Addendum No. 3

**Subject: SDP Contracts No. B-057 C, B-058 C, B-059 C and B-060 C of 2020/21
Major Renovation and Addition**

Location: Edwin Forrest Elementary School

This Addendum dated April 29, 2022 shall modify and become part of the Contract Documents. Any items not mentioned herein, or affected by this addendum, shall remain strictly in accordance with the original document, unless modified by prior addenda, if any.

DRAWING NO.
A-420

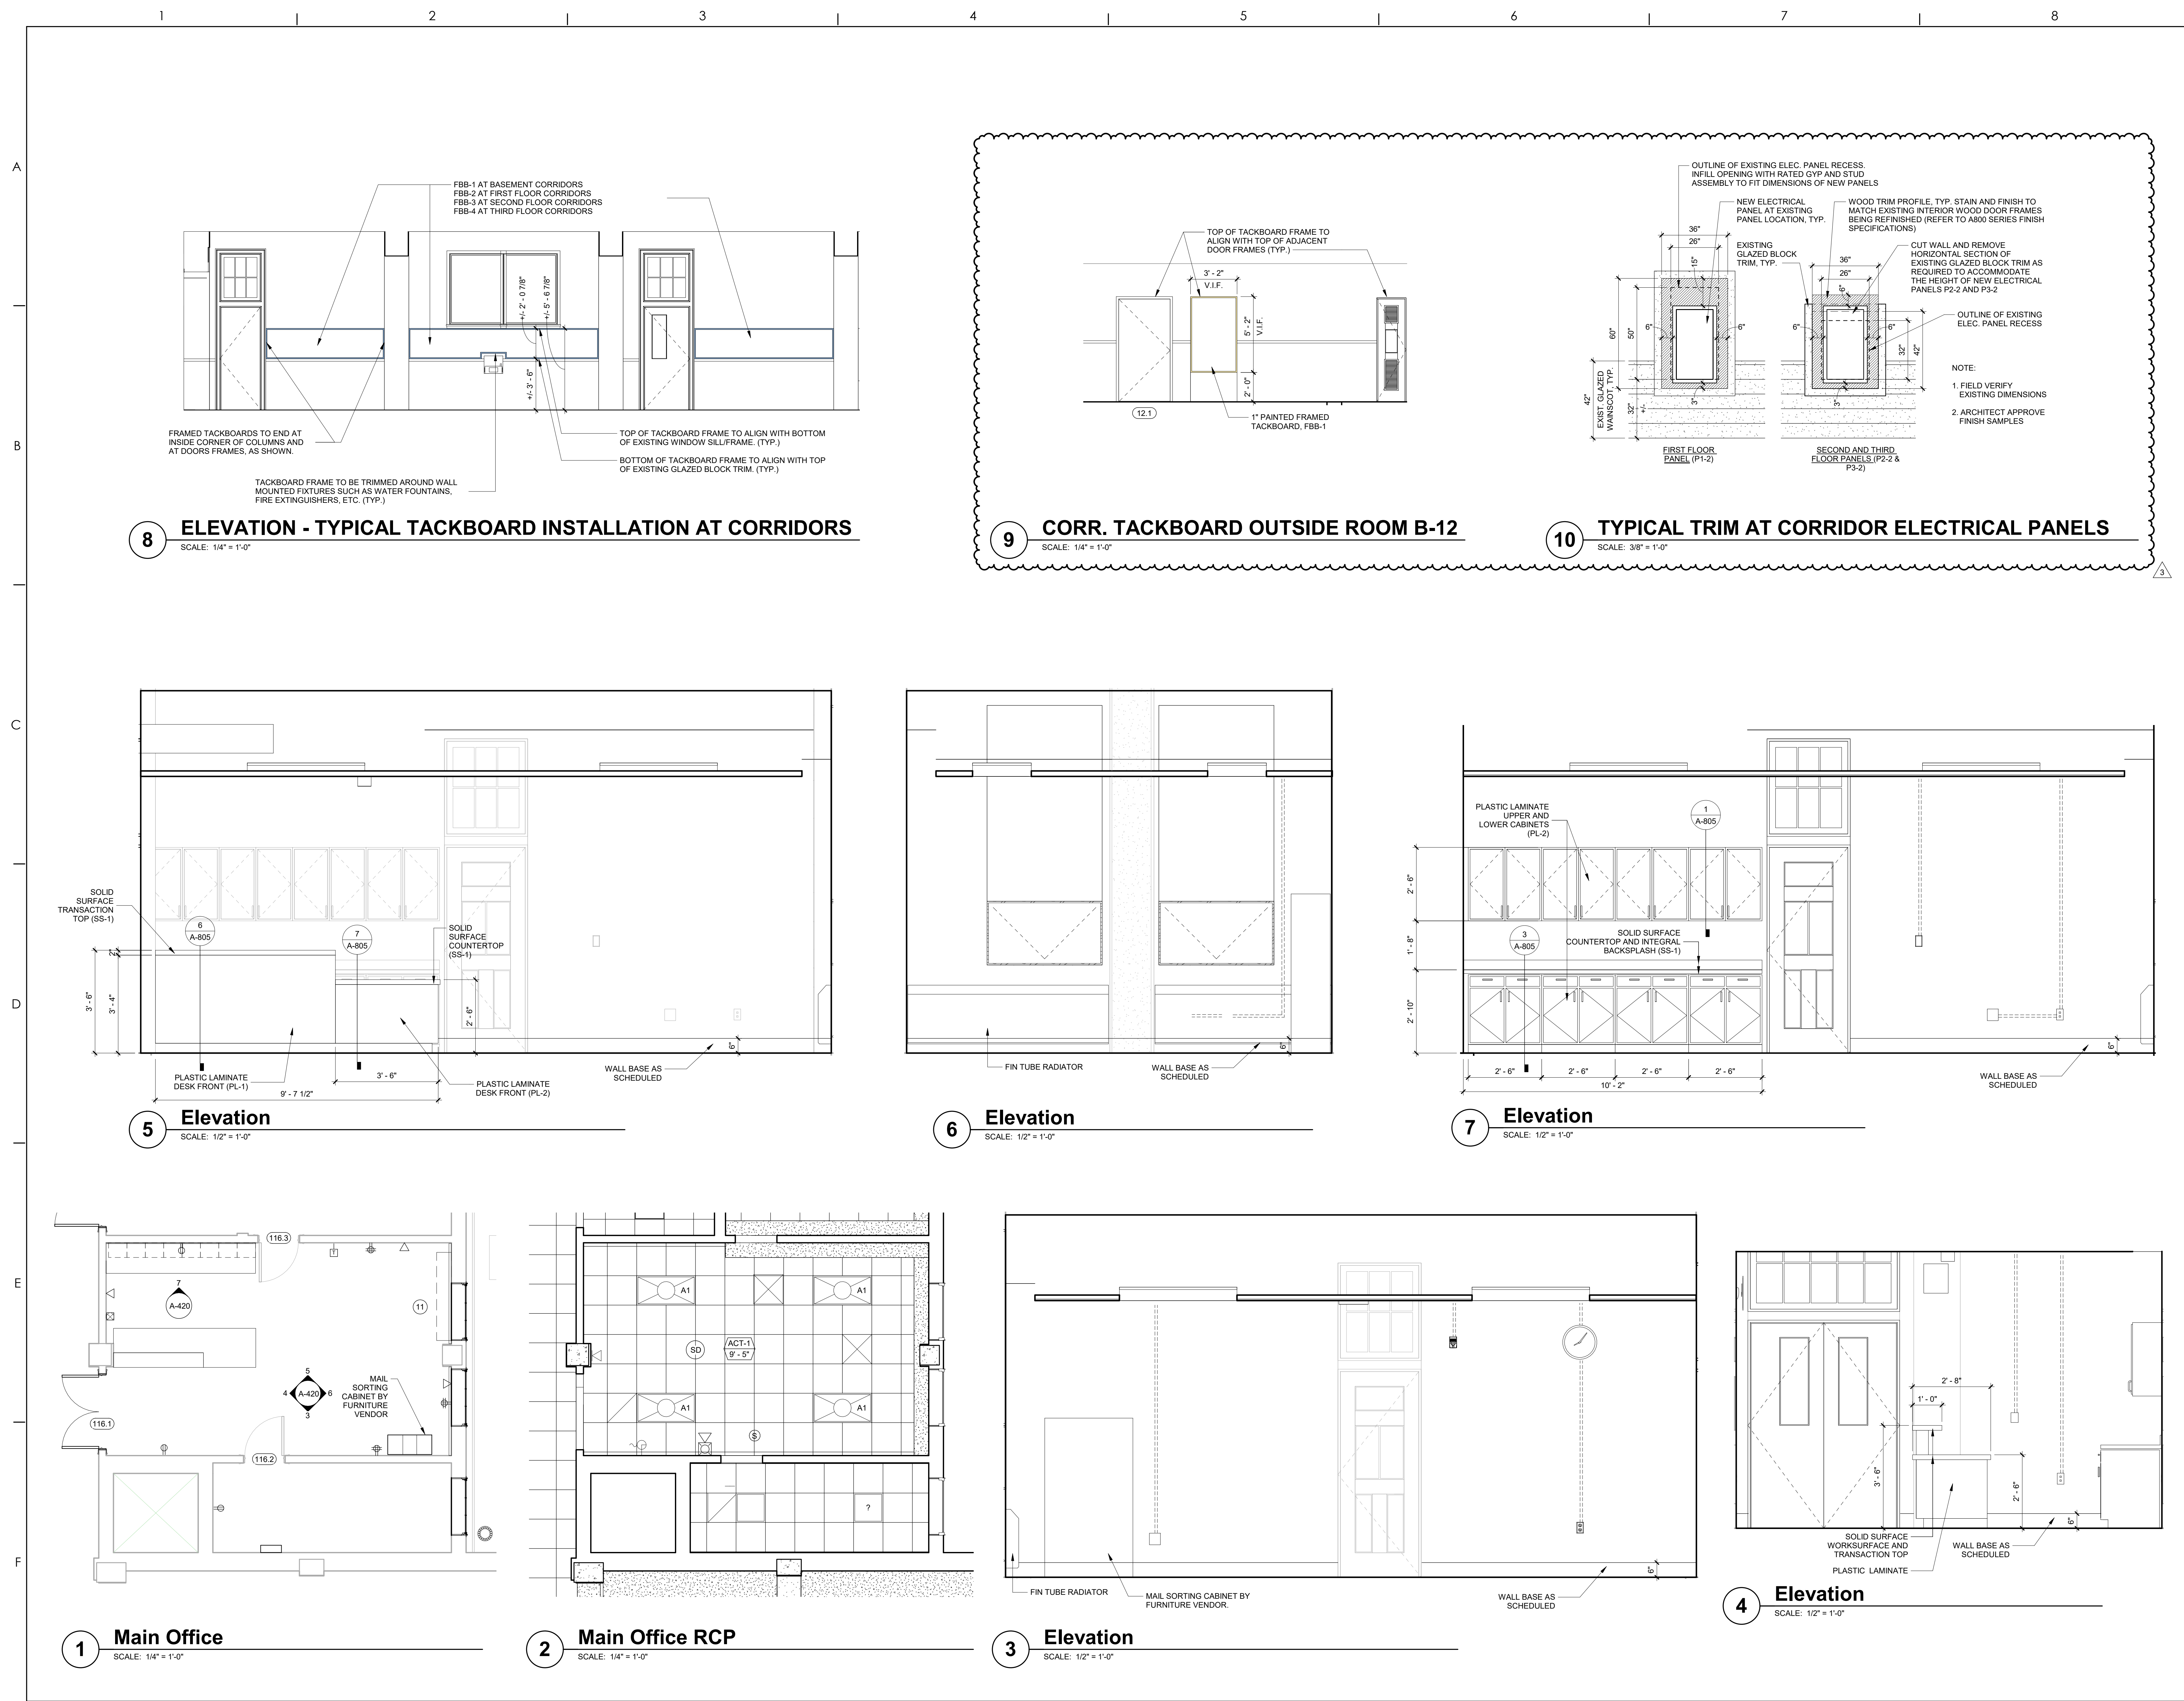
- A-420: Revised to provide additional corridor elevations
- E-400: Revised drawing to show MC provided, EC installed, line-voltage thermostats for unit heaters UH-1 through UH-7 in basement.
- E-503: Revised Mechanical Equipment – Electrical Data Schedule for EC to provide and install disconnects for IHRU equipment.

DRAWING NO.
E-400

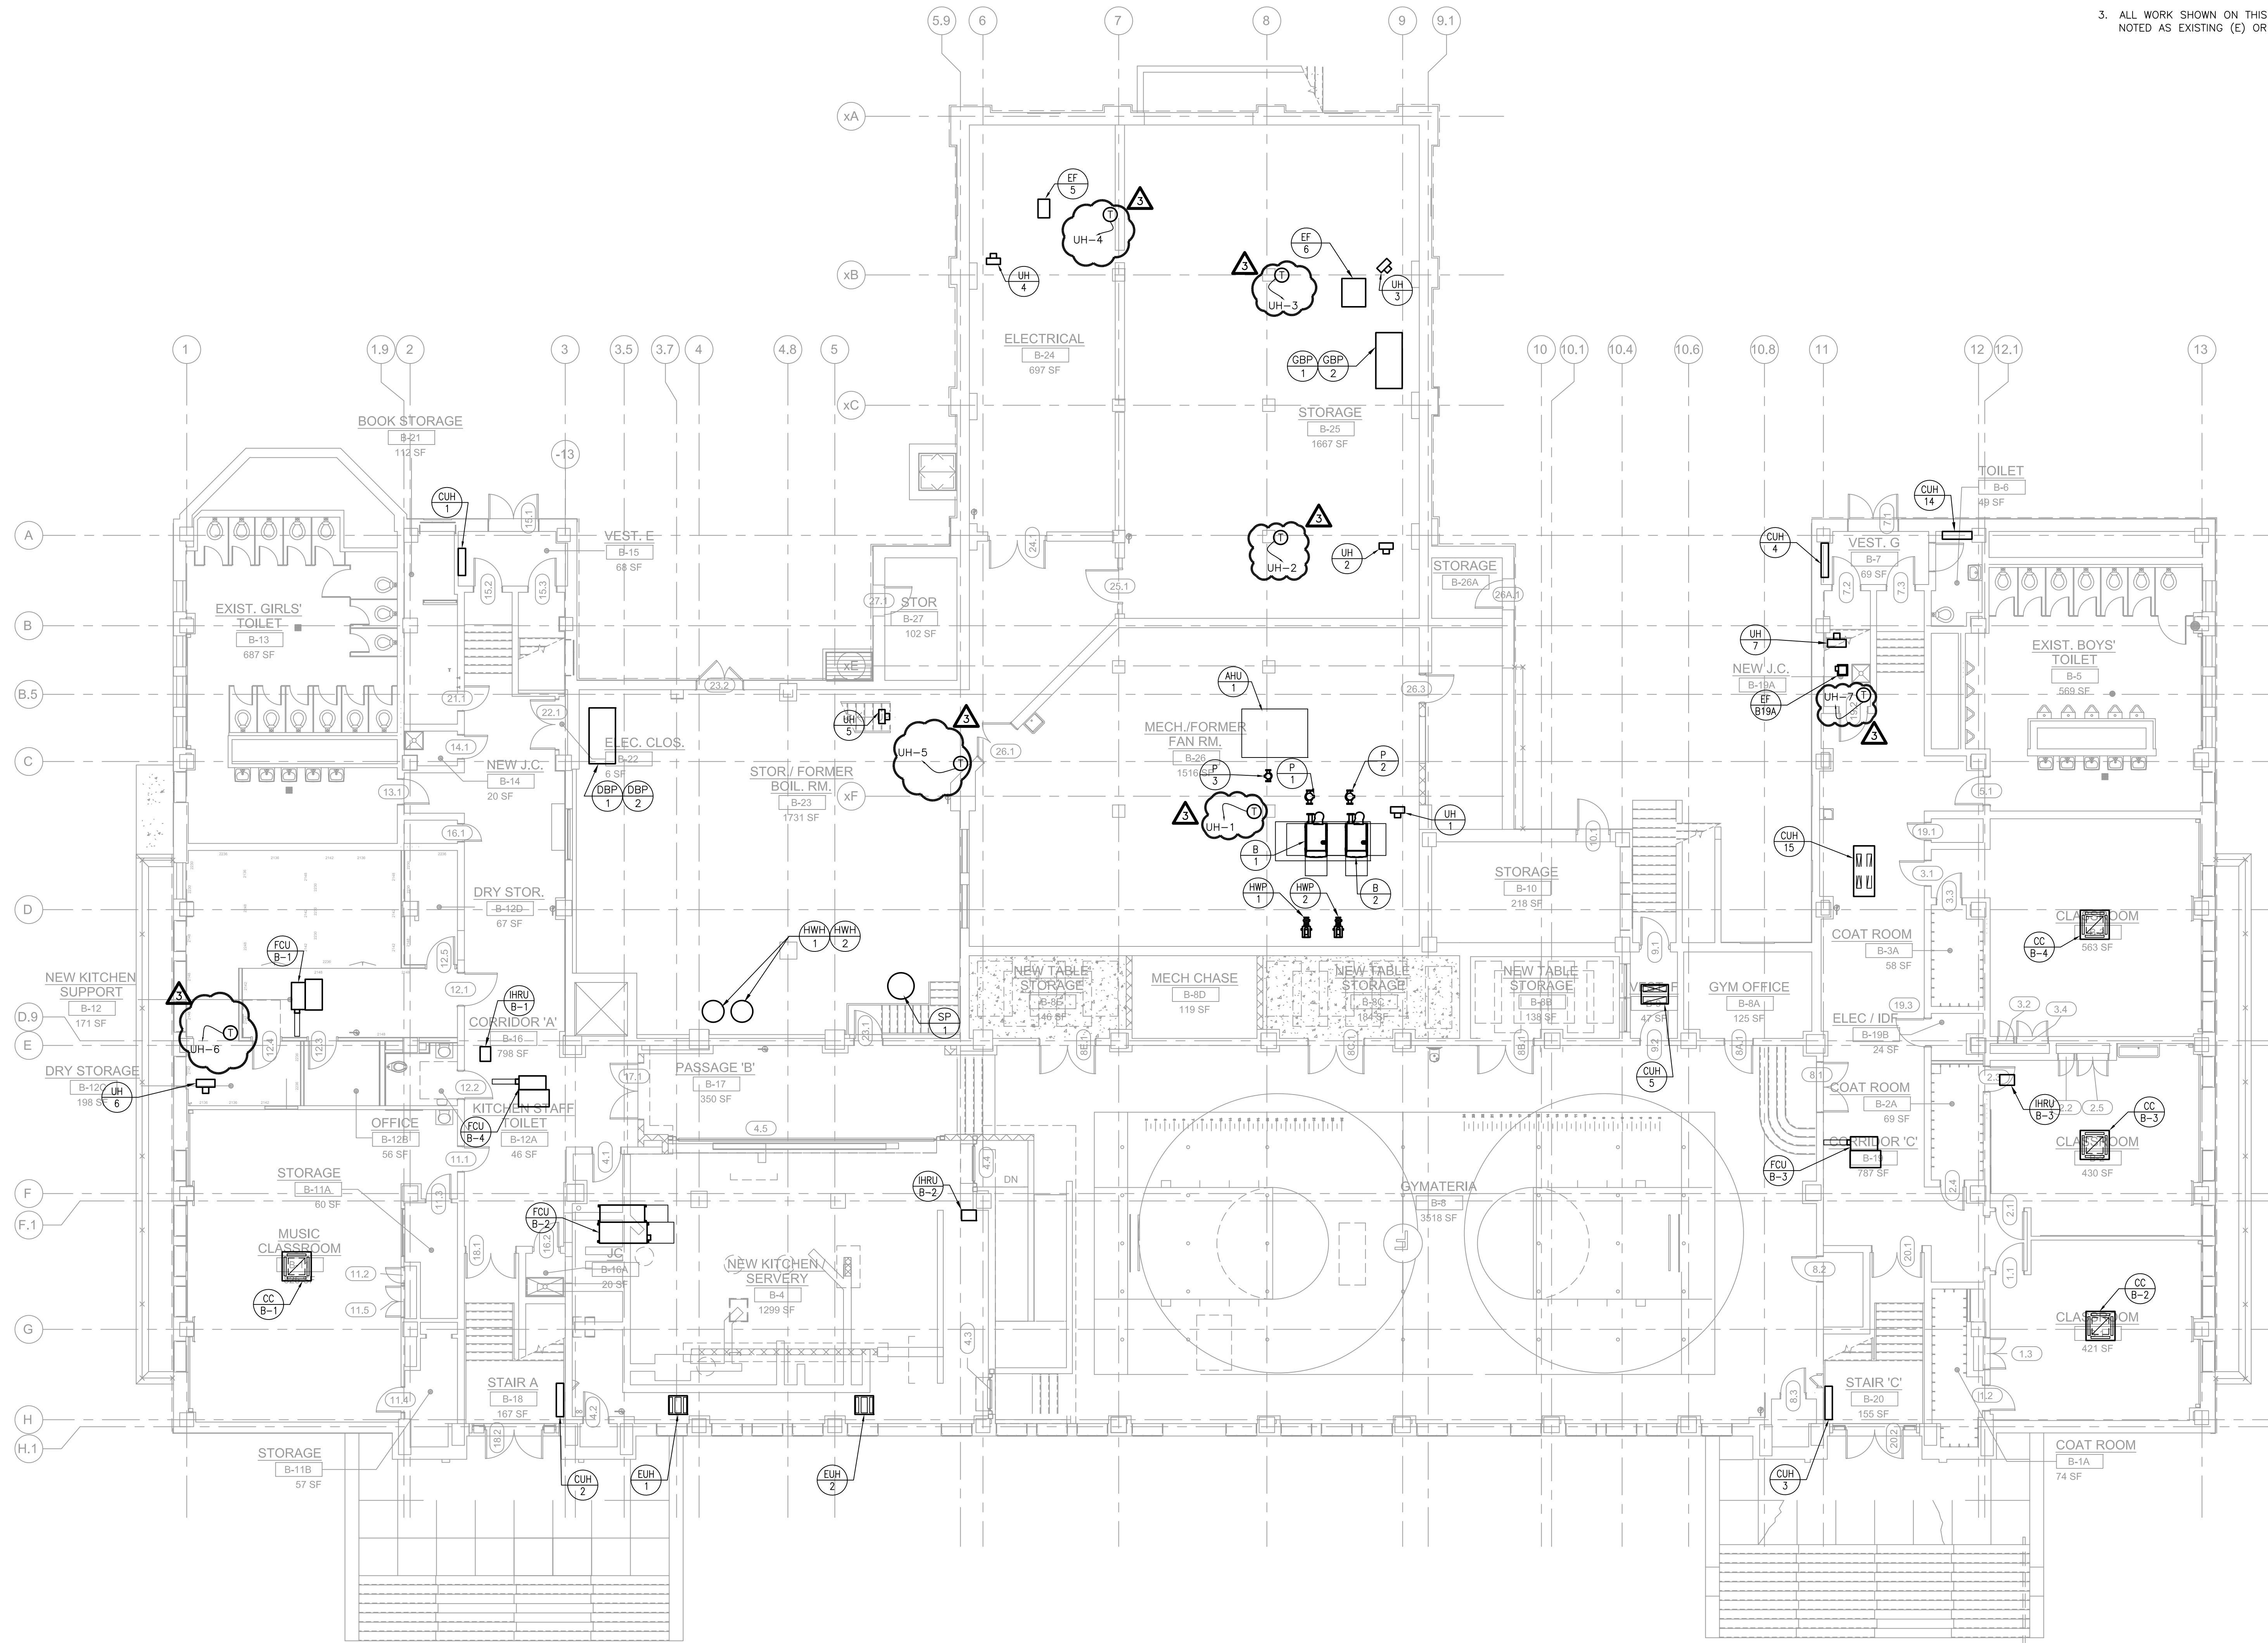
Answer: Thermostat locations are shown on mechanical drawings. Where line-voltage thermostats are referenced in the Electrical Data Schedule on E-503, the associated conduit and wiring is by the EC. Refer to enclosed revised Dwg E-400 for line-voltage thermostat locations associated with unit heaters, as the EC is to wire the unit heaters via the line-voltage thermostats, per the Remarks column on drawing E-503.
